Recall Bulletin

SUBJECT: Loss of Battery Charge – Inspect Generator Control Module

MODELS: 2012-2013 Buick LaCrosse, Regal
2013 Chevrolet Malibu Eco
Equipped with eAssist

GM Recall #13136

Important Part Inspection

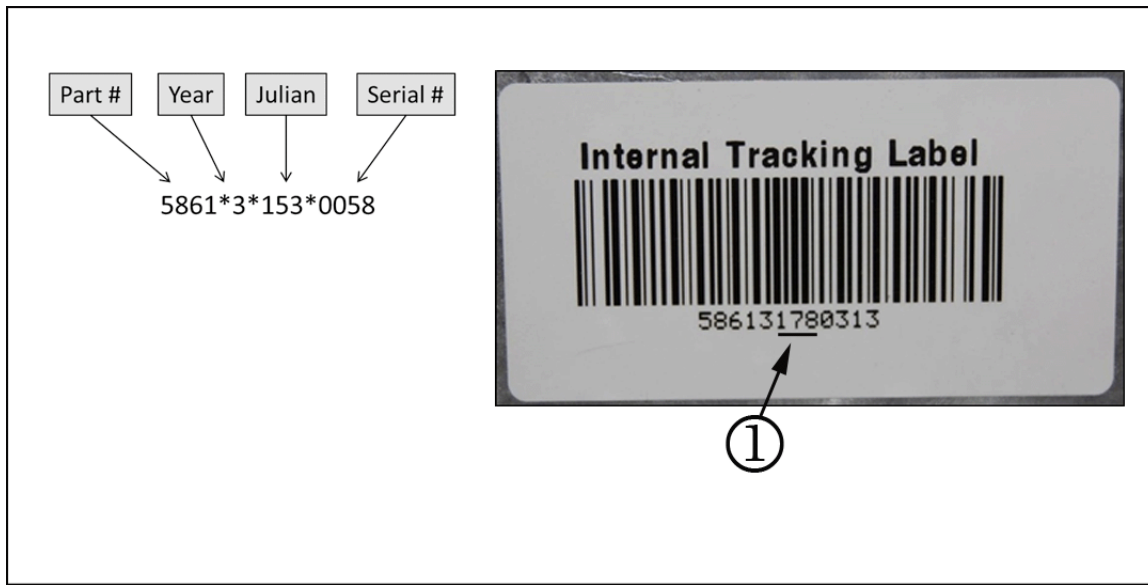
Generator Control Modules (GCM) with part number 24269448 or 24266403 require an inspection prior to installation in a vehicle. GCMs with part number 24267940 or 24267941 do NOT require inspection prior to installation in a vehicle.

Do NOT provide technicians with GCMs (p/n 24269448 or 24266403) that have a Julian date of 171 through 199. Determine the Julian date following the steps below. Return modules that fail the inspection according to Special Return Bulletin #G_0000171850.

1. Locate the barcode label on the new GCM.

2. Determine the Julian date (1) as shown above.
 - If the Julian date (1) is 171 through 199, do NOT install the module. Obtain another module and perform the inspection again.
 - If the Julian date (1) is NOT 171 through 199, provide to the technician for installation in the vehicle.

Part Inspection Procedure

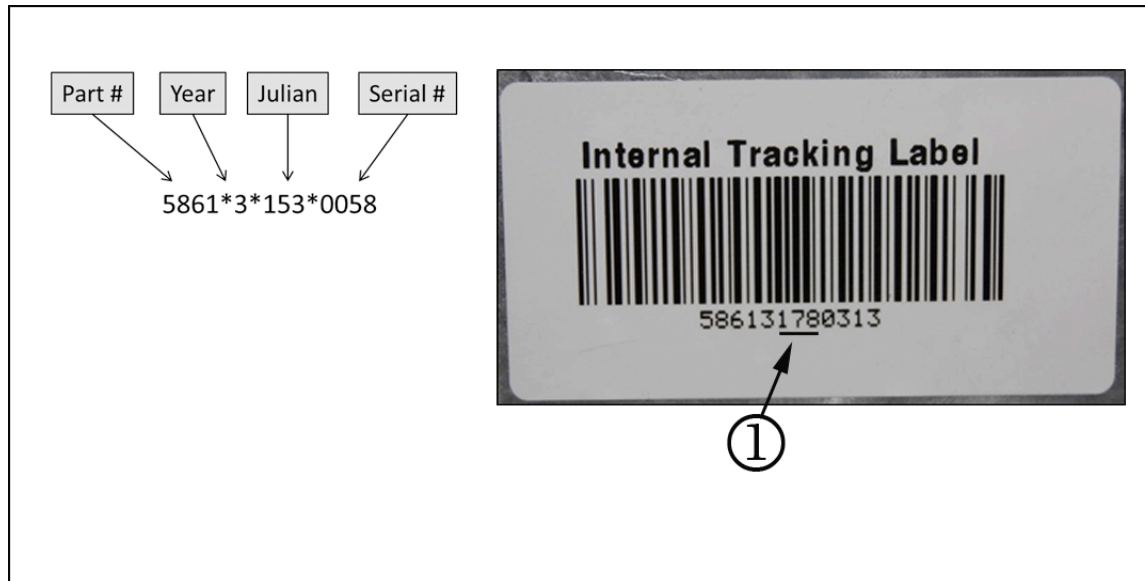
Note: Do NOT install GCMs with a Julian date of 171 through 199. Return those modules according to Special Return Bulletin #G_0000171850.

3. Locate the barcode label on the new GCM.
4. Determine the Julian date (1) as shown above.
 - If the Julian date (1) is 171 through 199, do NOT install the module. Obtain another module and perform the inspection again.
